PROJECT NO. 3-73180
**JUNEAU-AURORA HARBOR FACILITIES
 &
 TAKU HARBOR REPAIRS**

AS BUILT

STATE OF ALASKA DEPARTMENT OF PUBLIC WORKS
DIVISION OF WATER & HARBORS

STALL FLOAT ANGLE BRACE
Scale 1" = 1'-0"

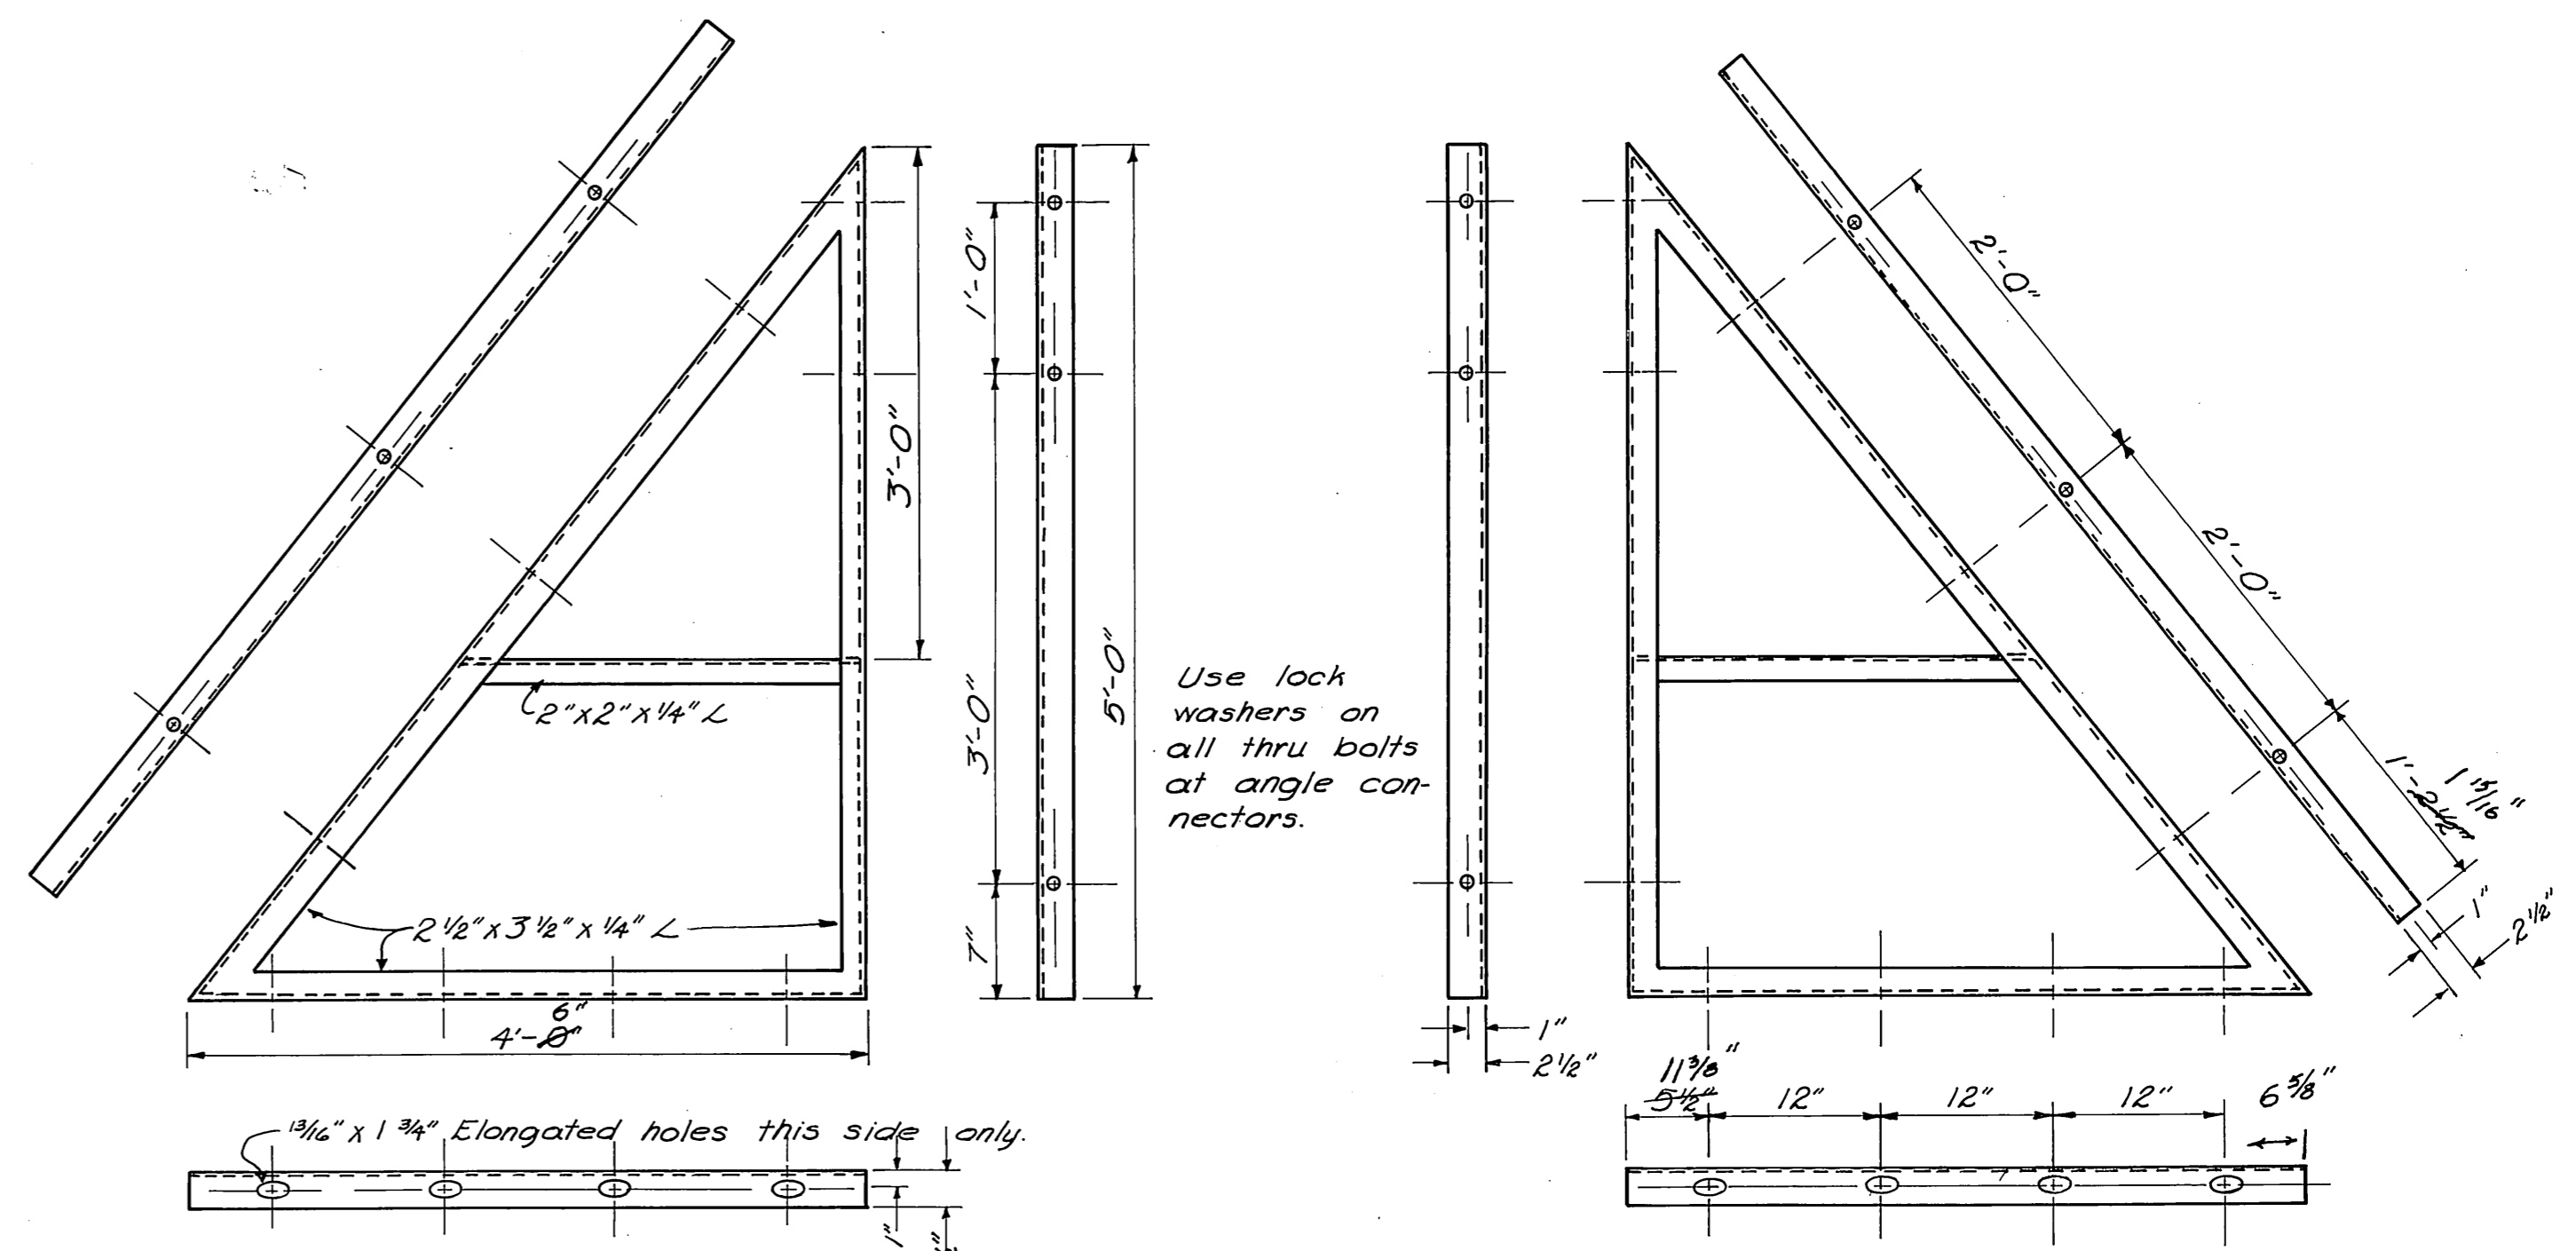
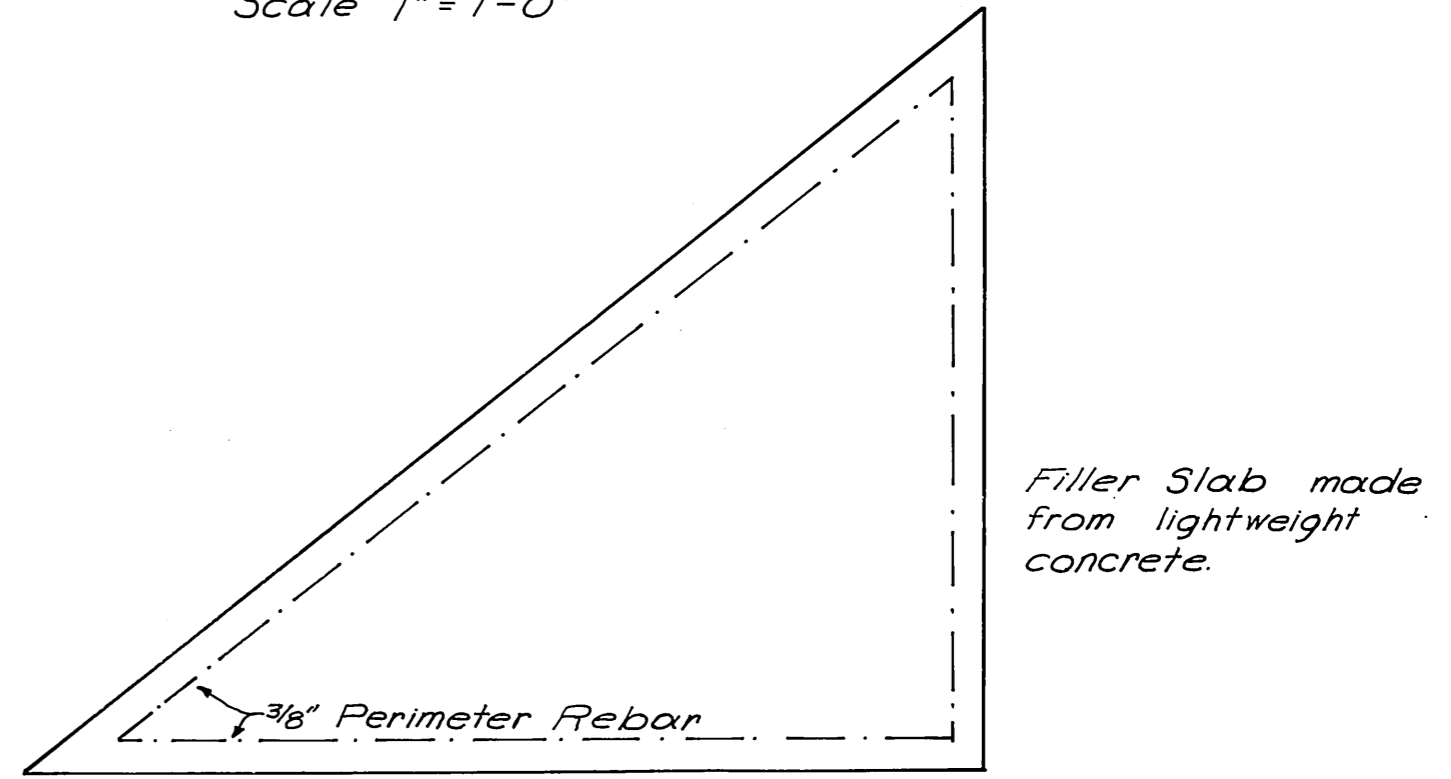
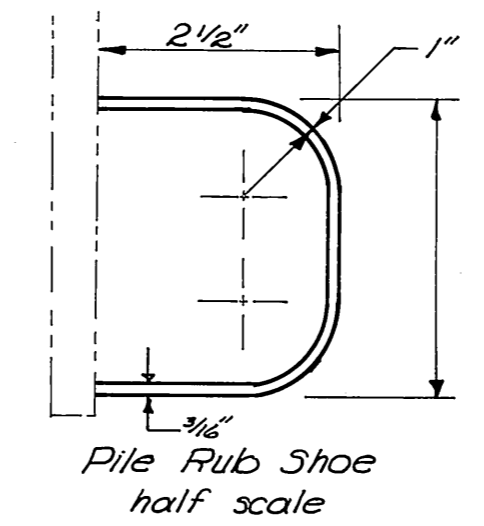
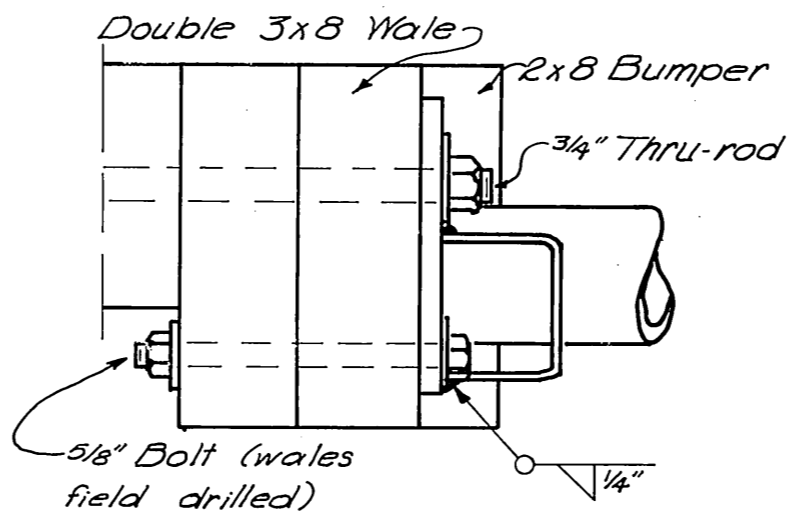
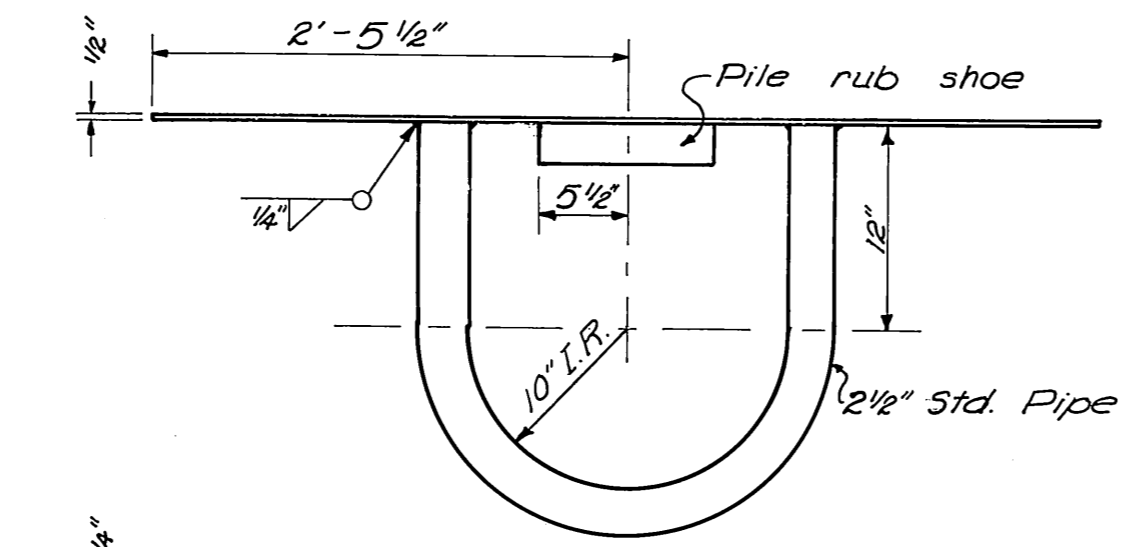
Dimension changes made by fabricator for unknown reasons on angle braces - error on their part
Angle concrete filler slabs had to be modified and reordered to fit modified angle braces
